2nd Revised Response to Request for Additional
Information No. 841-6055 Revision 3

US-APWR Design Certification

RAI NO.: NO. 841-6055 REVISION 3
SRP SECTION: 03.04.01 – INTERNAL FLOOD PROTECTION FOR ONSITE EQUIPMENT FAILURES
APPLICATION SECTION: 3.04.01
DATE OF RAI ISSUE: 10/18/2011

QUESTION NO.: 03.04.01-29:

Figure 10.4.9-2 Emergency Feedwater System Piping and Instrumentation Diagram (2/2)

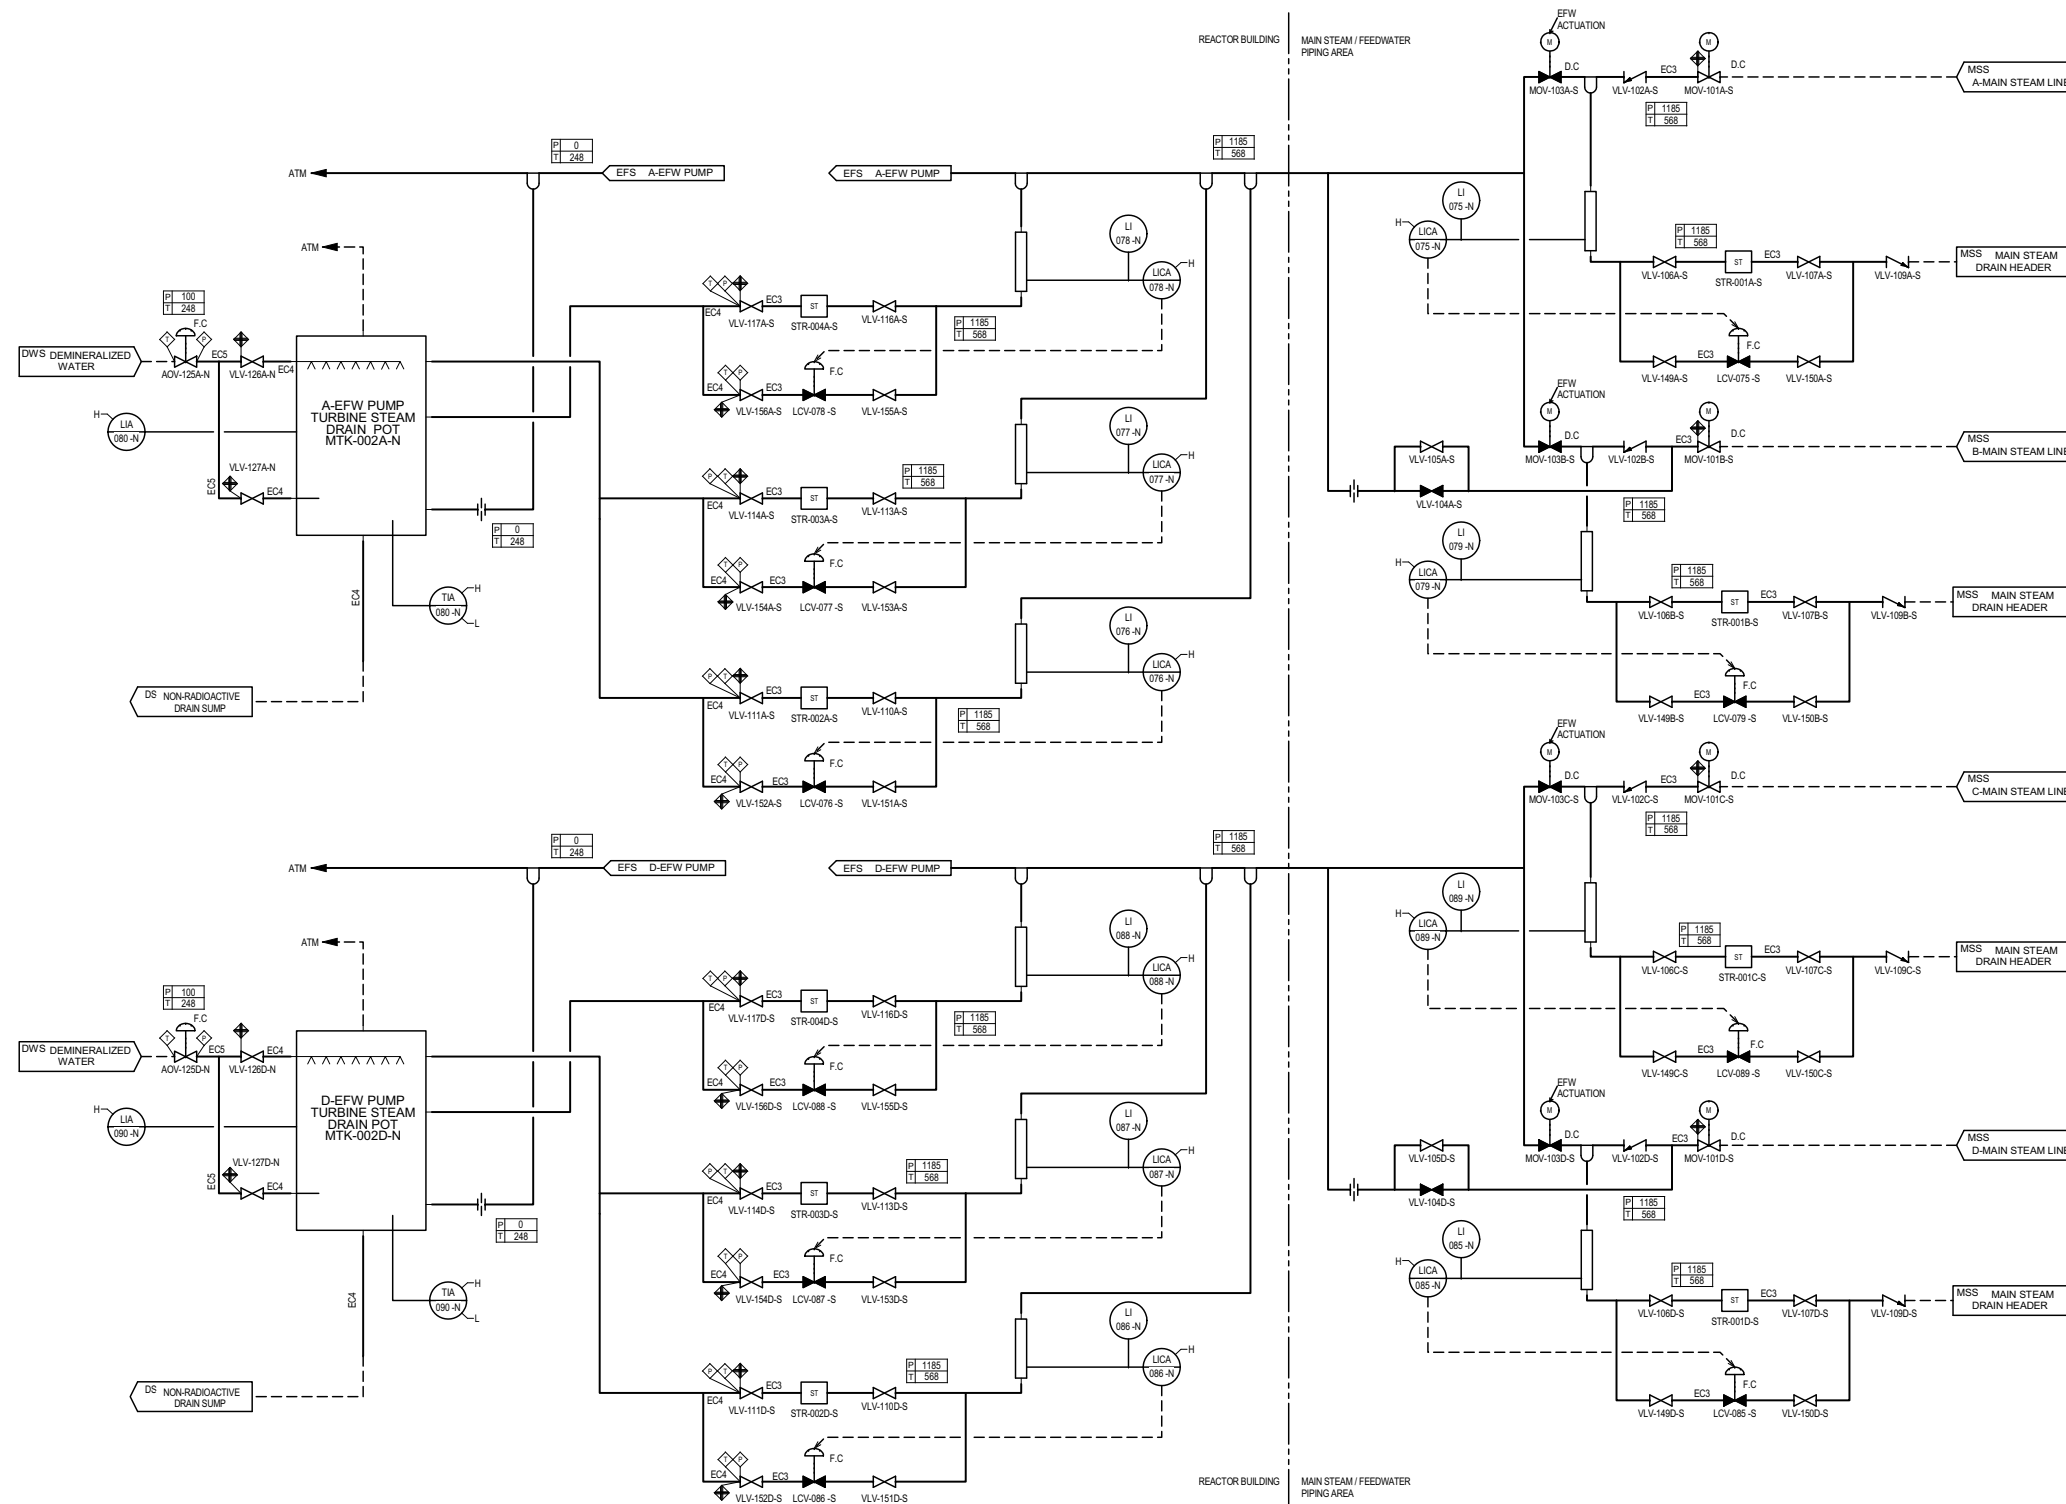
The following portions of the DCD are revised to reflect the updated equipment class and seismic category of water-containing piping on which the flooding evaluation is based.

Tier 2	Chapter 3	Section 3.2.2, Section 3.4.1, Figure 3E-2, Figure 3E-6,	Table 3.2-2, Figure 3E-3, Figure 3E-9	Figure 3E-5,
	Chapter 5	Figure 5.1-2		
	Chapter 9	Figure 9.1.3-2, Section 9.2.2, Figure 9.2.6-2, Section 9.2.7, Figure 9.3.2-1, Figure 9.3.4-1, Section 9.5.1	Figure 9.2.2-1, Figure 9.2.6-3, Figure 9.2.7-2,	
	Chapter 10	Figure 10.4.9-2
